| APPLICANT: First Center, Inc. | PETITION NO: | Z-37 |
| PROPERTY LOCATION: Southwest intersection of Shallowford | | |

Applicant is requesting the FST zoning category for the development of a 70-lot detached townhome subdivision. The townhomes will be traditional in architecture. The proposed site plan indicates variances will be required and include: waiving the front setbacks from the required 35 feet (exterior lots) or 25 feet (interior lots) to 13 feet; waive the major side setbacks from 25 feet or 35 feet to 13 feet, 15 feet and 20 feet; waive the required rear setback from the required 35 feet (exterior lots) or 25 feet (interior lots) to 20 feet (exterior) and 0 feet (interior); waive the side setback from the required 40 feet (exterior lots) or 10 feet (interior lots) to 0 feet (3.5 feet between detached units); and allow detached units in the FST zoning district.

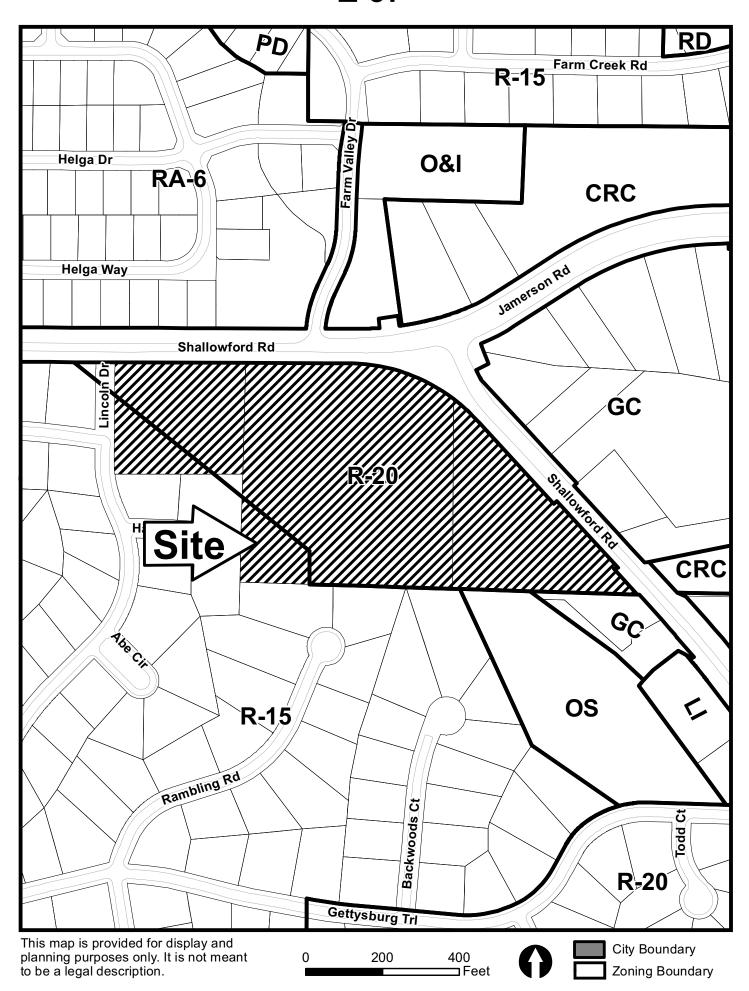
- 2. The proposed site plan shows only one detention pond at the northwest corner. However, since a significant portion of the site drains to the eastern stream channel, a second pond may be required which may reduce the total number of lots since the pond cannot be located within the stream buffer.

- 3. A drainage easement will likely be required along the rear of lots 9-18 to limit offsite runoff bypass.
- 4. Since private streets are proposed all stormwater management within the development including the detention pond(s) will be privately maintained in perpetuity by the HOA.
